**CITY OF SAN ANGELO**  
**BELL STREET PAVING, WATER AND WASTEWATER IMPROVEMENTS PHASE I**  
**SAN16188**

**ADDENDUM NO. 1**  
**July 27, 2017**

**00 91 13      ADDENDUM NUMBER 001**

## **PHASE 1 PRE-BID QUESTIONS RESPONSE LOG**

SS-9

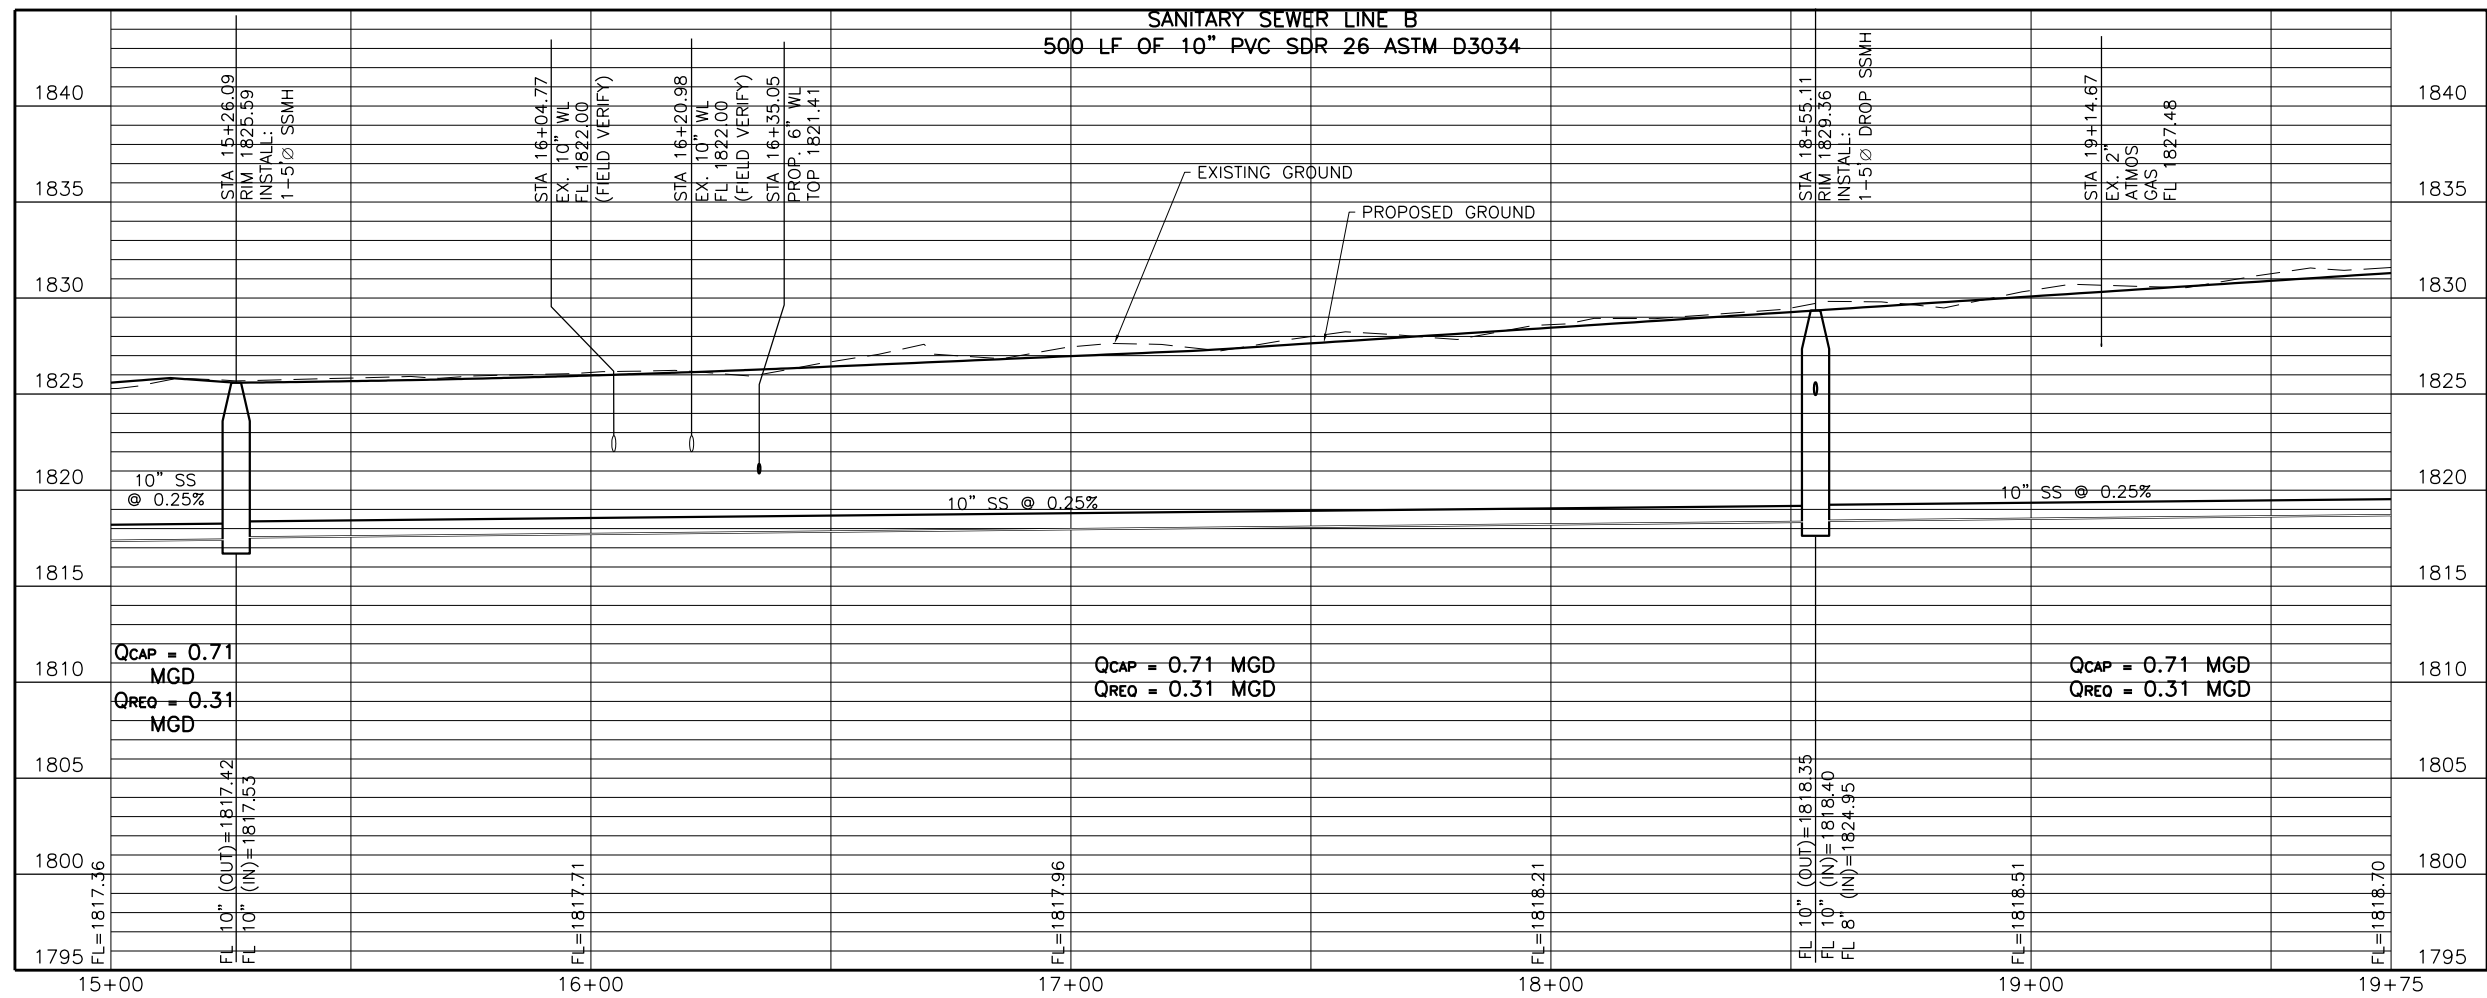
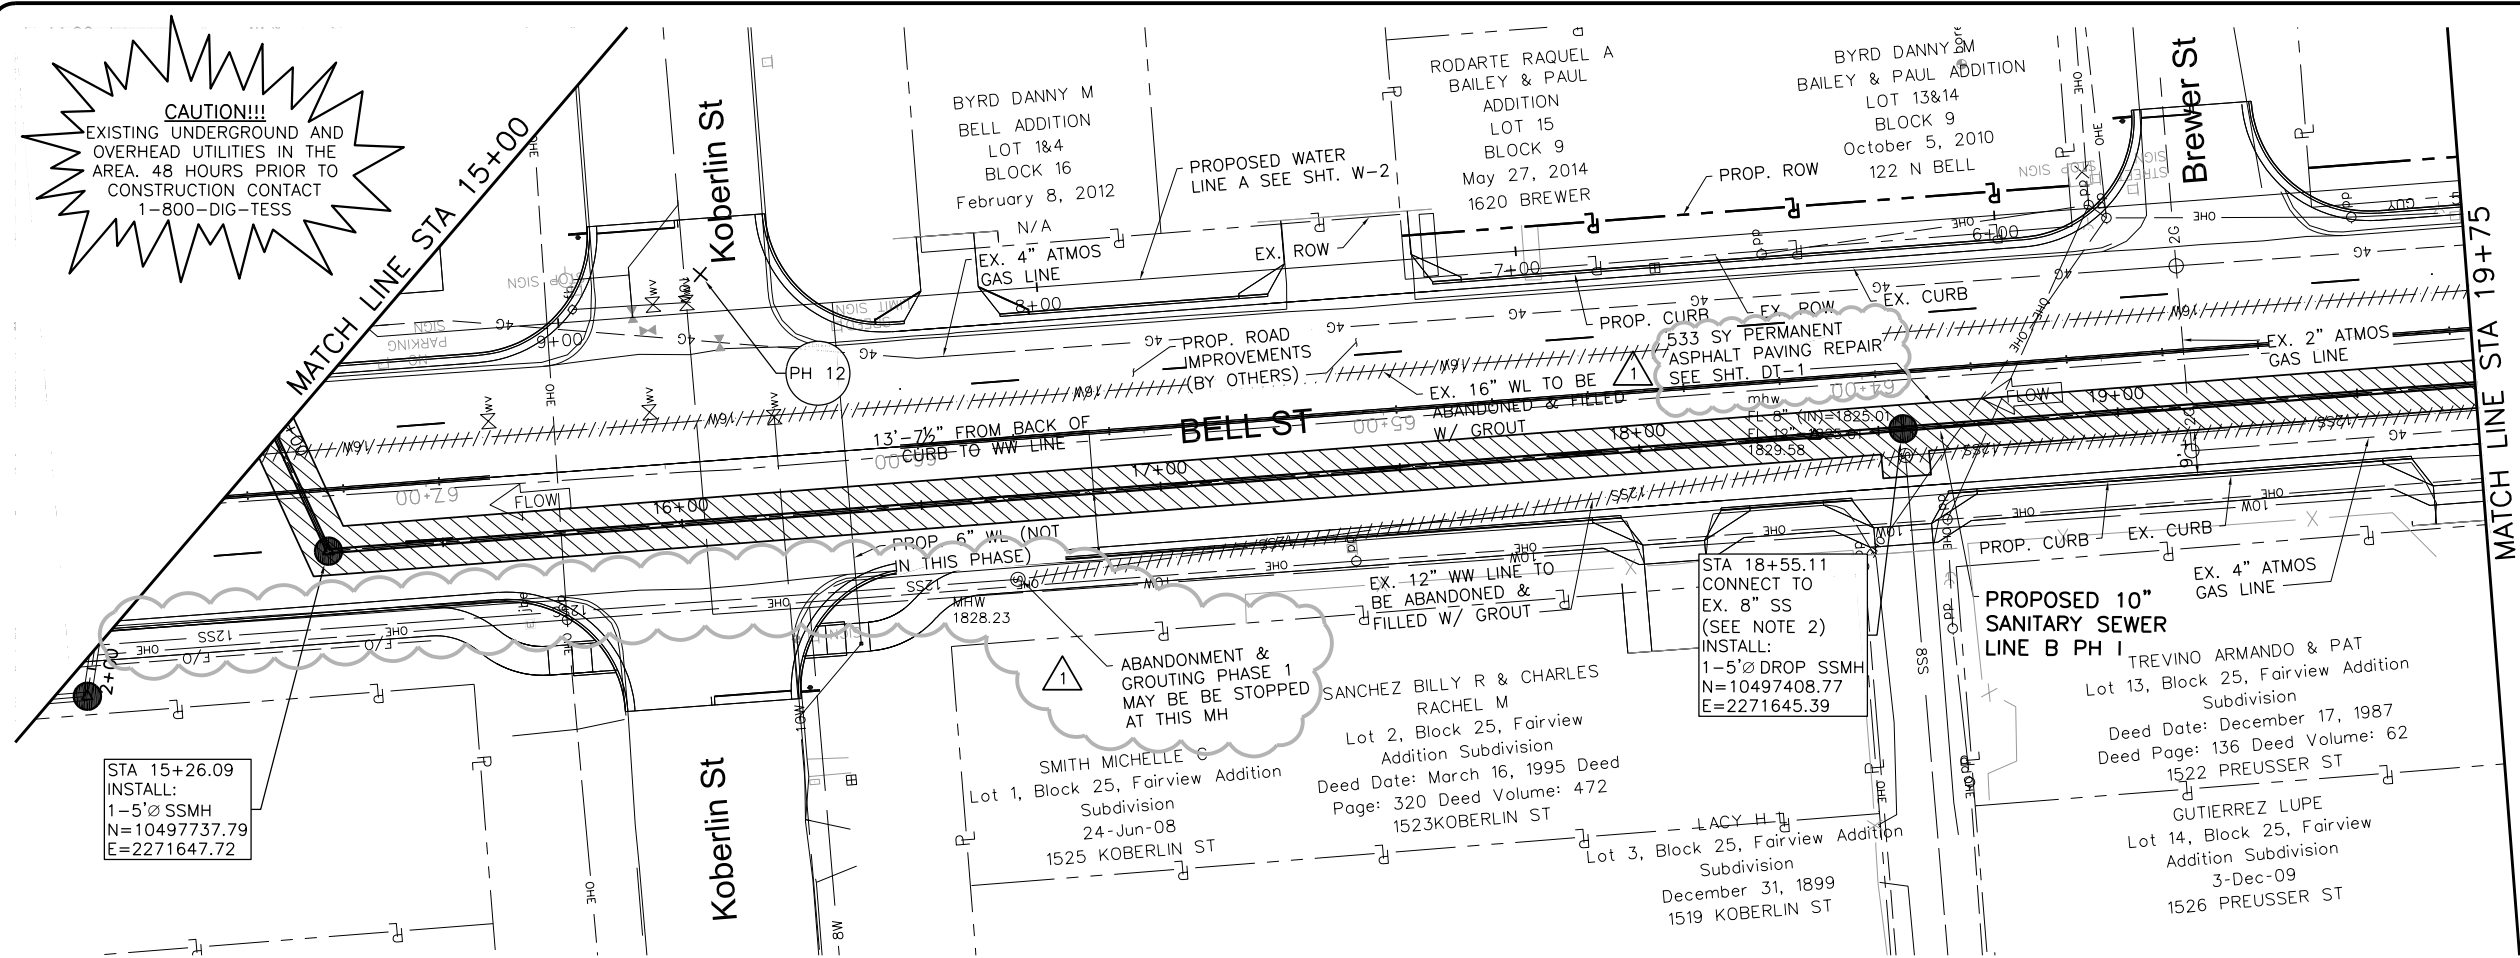
43	Is Trench Check Dam required to go the full trench as shown in the Details	The Trench Check Dam must adhere to the City Standard detail on Sheet DT-1.	None.
44	Clarify Phase I Abandonment and grouting stopping point for existing 12"SS	There is an existing MH at Koberlin and Bell St that will be a natural stopping point for the PH I grouting and abandonment of the existing SS.	Refer to Addendum 01, Updated Drawings section, Sheet SS-9 updated for additional clarification.

NO. ISSUE	BY	DATE	FOR JOB NO.	DATE	DESIGNED	DRAWN	REVIEWED	CHECKED	FILE NAME
			SAN116188	07/07/17	ABC	ABC	SB		WASTEWATER LINE B PH I.DWG
ADDENDUM NO. 1 Bar is one inch on original drawing. If not one inch on this sheet, adjust scale.									
SHEET SS-15									
SEQ. 133

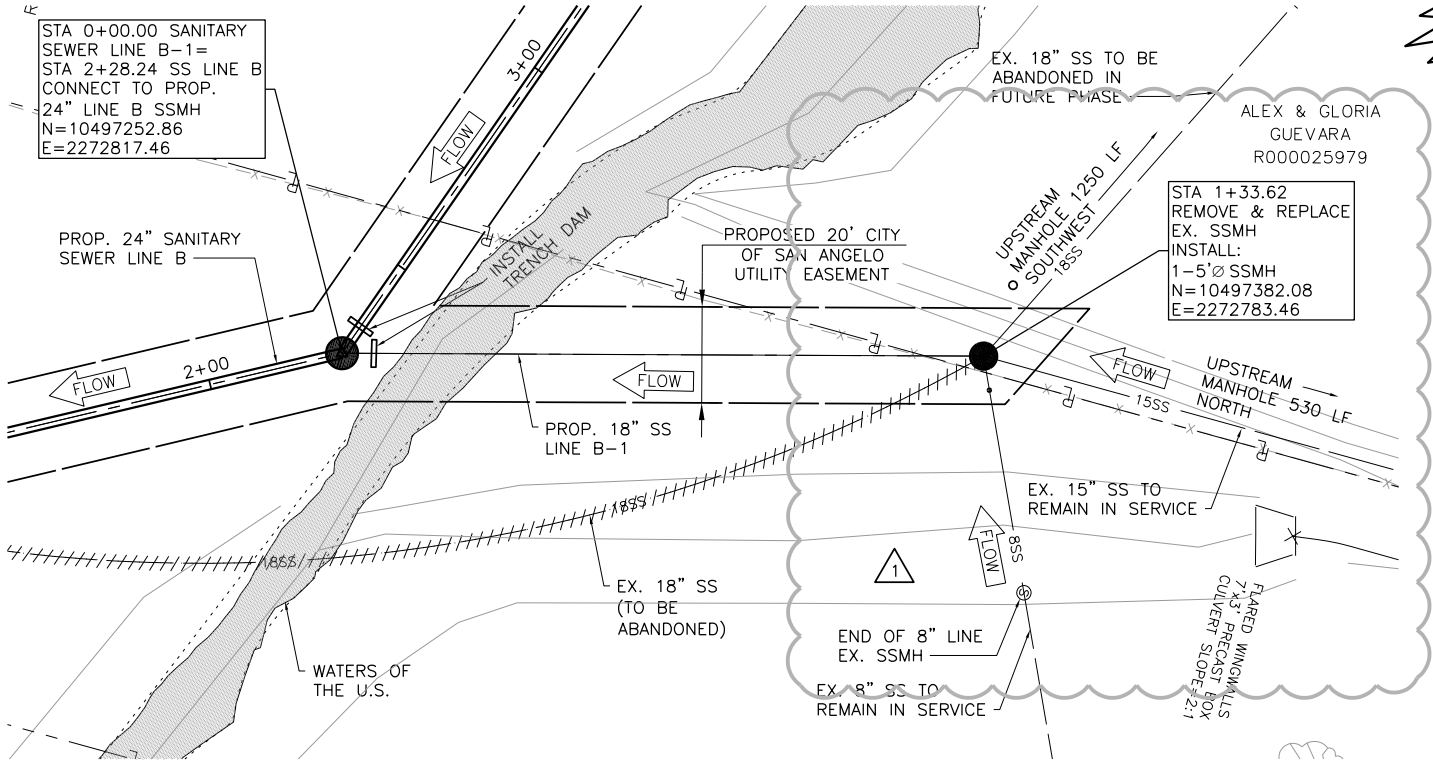
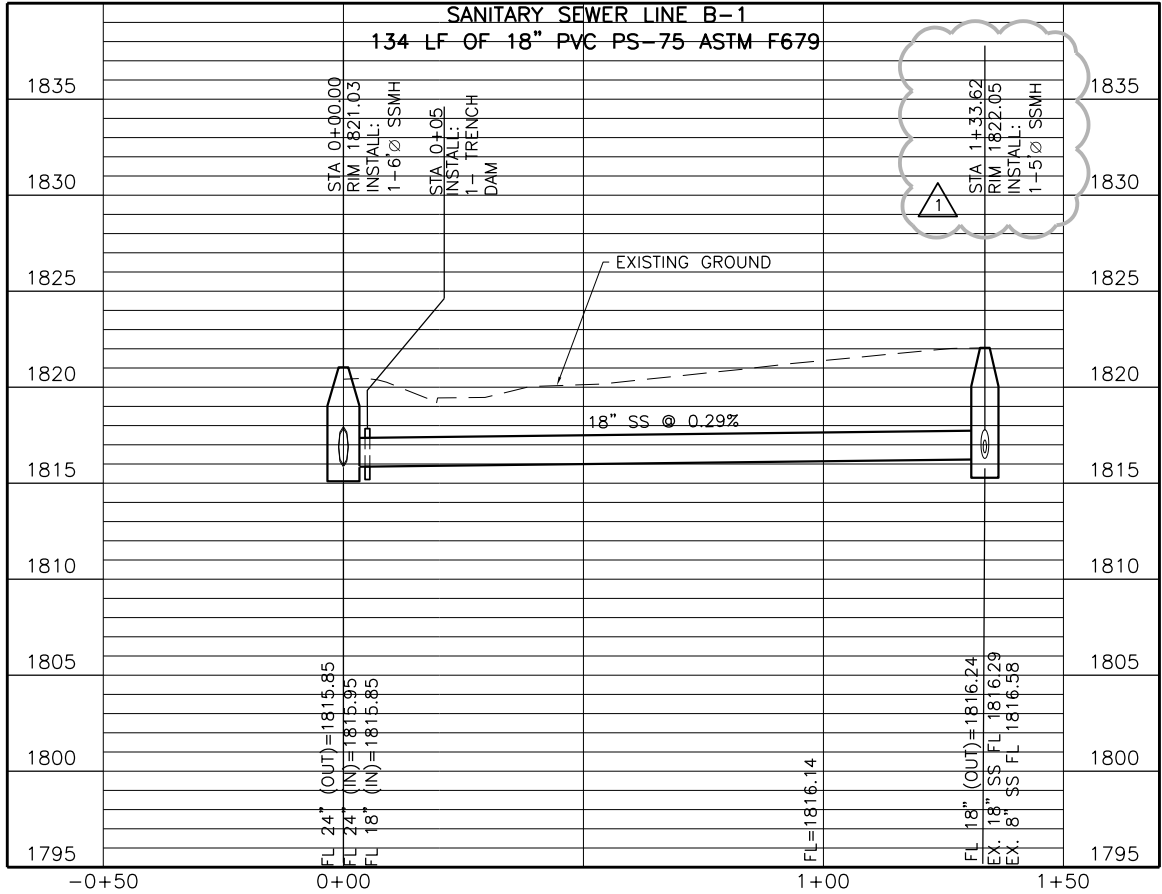
26	<p>Question: Plan sheet SS-6 and SS-15 the 18-inch sewer line to be abandoned on these sheets are they connected. If so does the bid item III-14 cover the line?</p>	Yes, they are connected.The quantity for Bid Item III-14 (Wastewater Line Abandonment Grout) covers this with the 158 CY.	Quantity confirmed

27	Question; Plan sheet SS-15 Shows remove and replace sewer man-hole that sits on one 18-inch sewer lines a 8 inch sewer line and a 15 inch sewer line. Can you give us the distance to the next upstream man-hole? For Bypass calculations?	Plan sheet SS-15 has been updated to show distances to upstream manholes and included in Addendum 01.	Sheet updated and reissued with Addendum 01.
28	Question; Plan sheet DT-8-3 Shows an epoxy coated eccentric CMP for the air and vacuum release valve vault. There is no such item can we use a fiberglass man-hole. Also, can we use schedule 80 pvc underground instead of DI. And galvanized pipe above ground? Can the Screen be PVC? The screen shown would have to be special made.	Detail updated per discussion at Pre-Bid Meeting with City of San Angelo and Utility Contractors.	Detail updated and revised Sheet DT-8 included as part of Addendum 01.
29	Question: Will we be able to close portions of Bell Street while installing sanitary sewer line?	No complete street closure is allowed. Partial closure (two lanes at a time, etc) is acceptable.	None.

50	On sheet SS-15 we are going to have to install an additional new man-hole on the existing 15 inch line and the existing 18 inch line as well as the man-holes shown on plan sheet. If more than one man-hole is being by-passed and it's within a 100 feet of each Other can the by-pass contractor representative watch both pumping systems for the 7 day period?	The current alignment and MH location deliver a complete system and we do not believe that additional manholes are necessary.  If the Contractor can maintain visual contact with both bypass pump set ups and meet the response time then yes, you may have the same person monitoring both pump set-ups.	None. Refer to Addendum 01, Updated Technical Specifications, Specification 4.29 for requirements.
51	Also, Item II-19 calls out a 8" x 2" Tapping Saddle and valve at station 3+19.89 but before that at station 2+78.01 there is a 8" x 2" Tee reconnect. How is the 8" Saddle possible if we are on a 2" line already. Please clarify.	The Saddle has been changed to a tee for the reconnection to the existing Water Meters and 2" WL in that location.	Sheet W-11 has been updated as part of Addendum 01.

4.1.25 All abandonment of pipeline under proposed pavement shall be grouted to include the 18-inch sanitary sewer being abandoned on Sheet SS-15. All abandonment of pipeline outside of proposed pavement with the exception of the 18-inch sanitary sewer, shall be cap and plug and grouting is not required.
